Cambium Networks Cambium Networks, Inc. 3800 Golf Road Schaumburg, IL 60008, U.S.A.	Document Number	FSB 9075
	Revision	000v001
FIELD SERVICE BULLETIN cnPulse and PMP 450m sync issue in CambiumSYNC mode	Application	Global
	Effective Date	13 February 2019
	Expiry Date	N/A

SUBJECT: cnPulse does not support PMP 450m in drop-cable mode

MODEL / SYSTEM AFFECTED: cnPulse (C000000L066A) and PMP 450m

Incorrect Installation

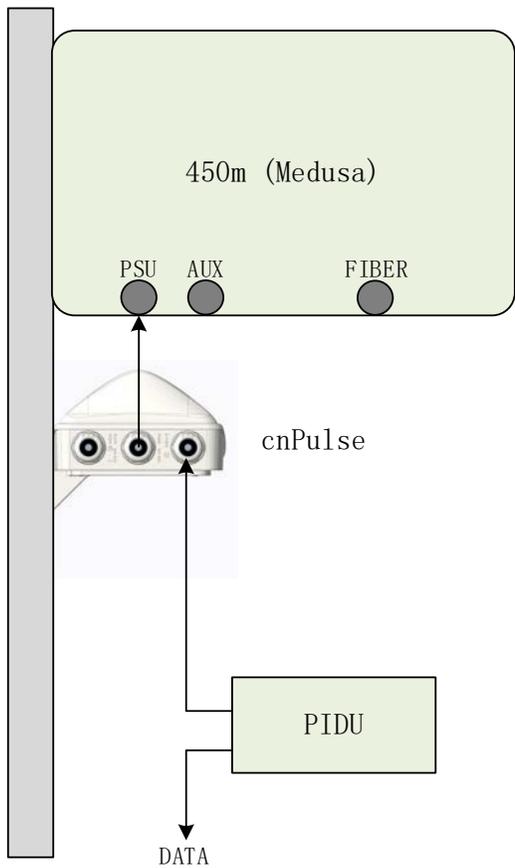
A GPS sync issue has been identified for customers who have received the new cnPulse GPS Sync devices when attempting to install with PMP 450m in CambiumSYNC mode. In most cases it takes a long time for the PMP 450m to lock onto the sync signal from the cnPulse device. cnPulse and PMP 450m are compatible when utilizing the AUX port or alternately utilizing a CMM5 device.

NOTE: This notice serves to inform customers that GPS synchronization will be affected if they install PMP 450m with cnPulse in CambiumSYNC mode.

Cambium Networks has identified and isolated the issue within the cnPulse device and will make a revision to the product later this year. This revised unit will be reflected by a new revision and hardware model for the cnPulse. In the interim, GPS sync works via the auxiliary port on the cnPulse product. Customers are encouraged to only utilize cnPulse if they can install their PMP 450m using the auxiliary port or the CMM5.

It is highly recommended for all customers to install PMP 450m on cnPulse utilizing the auxiliary port.
